Title POWER_SEQUENCE		
Size Custom	Document Number NANOCOM-APL	Rev: A0.1
Date: <i>Thursday, May 18, 2017</i>		Sheet: 2 of 28

Title SOC_SATA_PCIE_USB		
Size Custom	Document Number NANOCOM-APL	Rev: A0.1
Date: Thursday, May 18, 2017		Sheet: 5 of 28

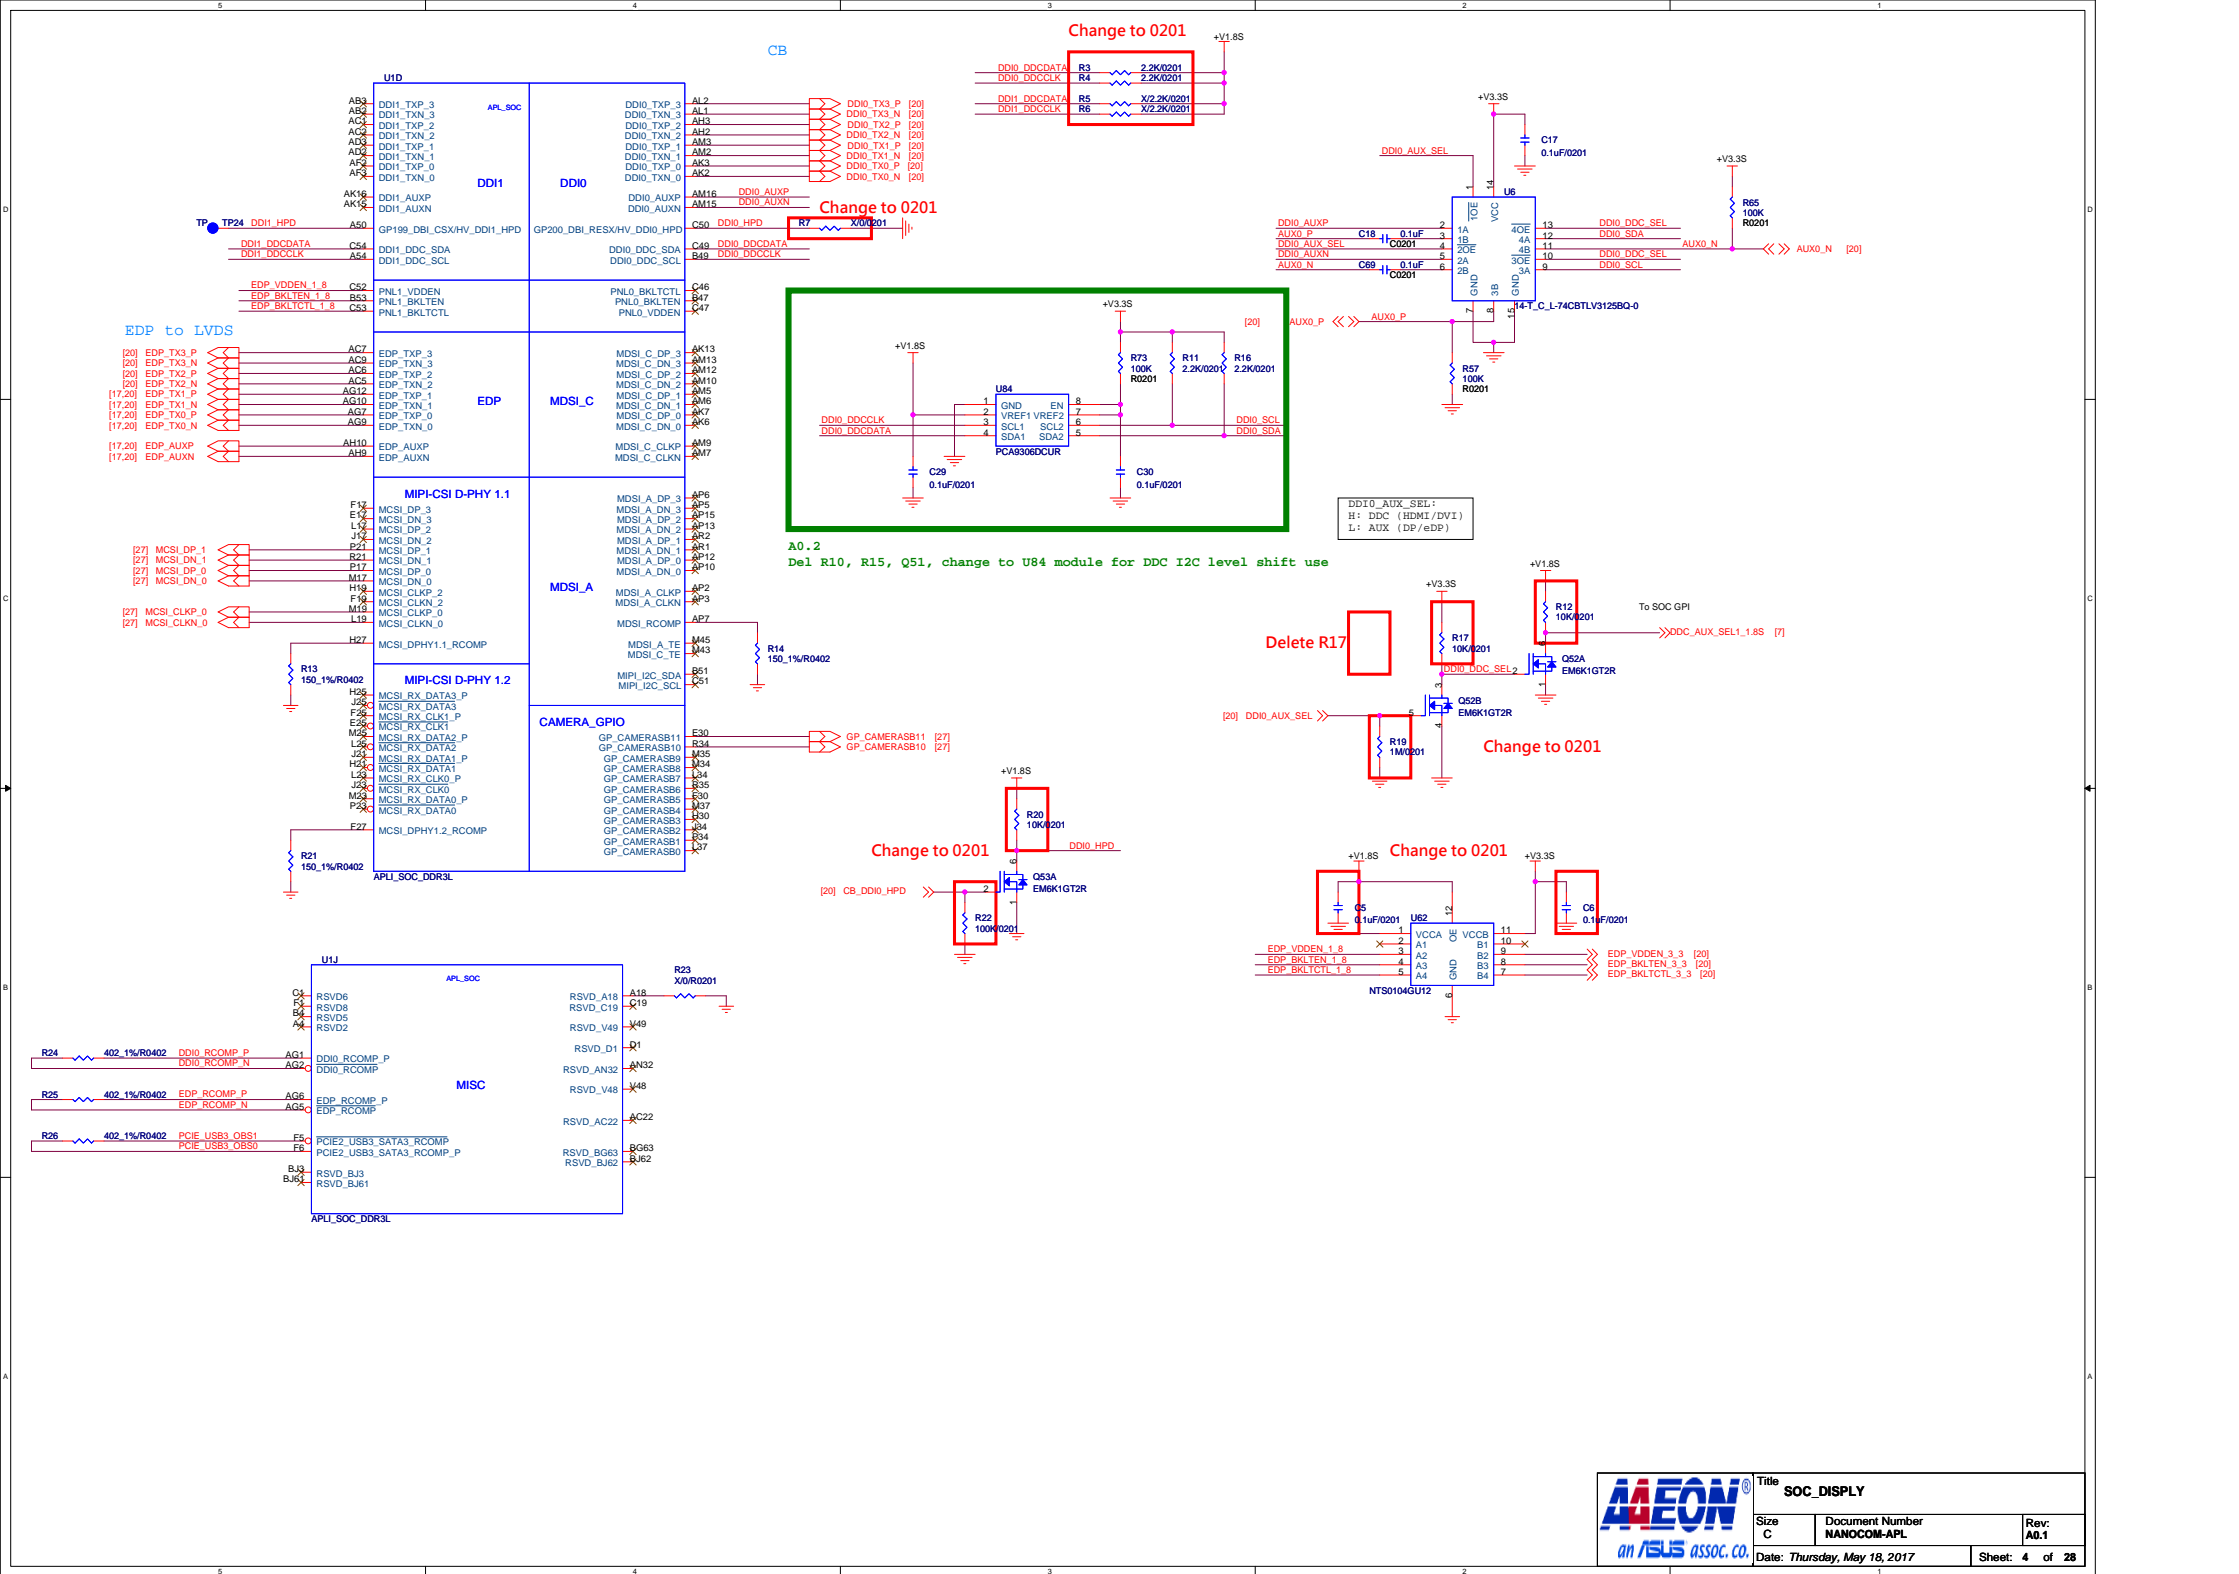
Change to 0201

Change to 0201

Change to 0201

Change to 0201

Change to 0201

Change to 0201

Title LAN i211		
Size B	Document Number NANOCOM-APL	Rev: A0.1
Date: Thursday, May 18, 2017		Sheet: 16 of 28

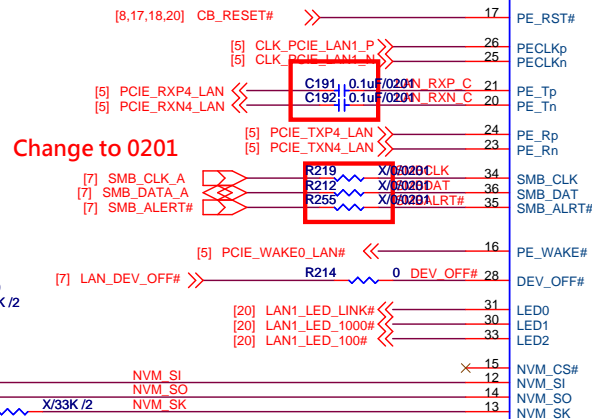
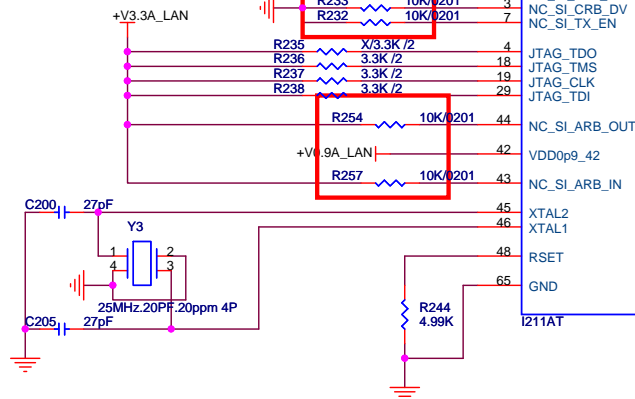
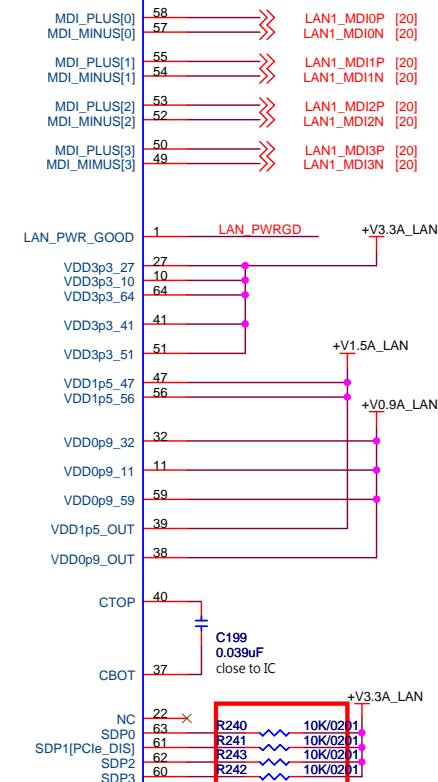
Change to 0201

Change to 0201

Change to 0201

Change to 0201

Change to 0201

Change to 0201

Title NB679GD_+V5A		
Size A	Document Number NANOCOM-APL	Rev: A0.1
Date: <i>Thursday, May 18, 2017</i>		Sheet: 23 of 28

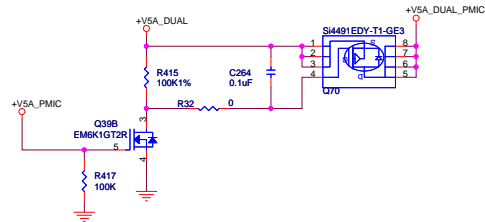
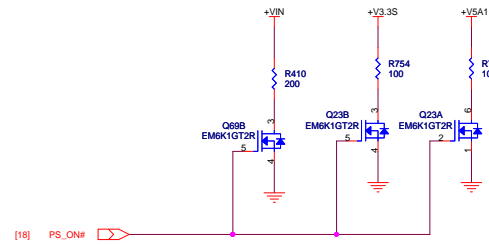
Delete U85 Load switch module
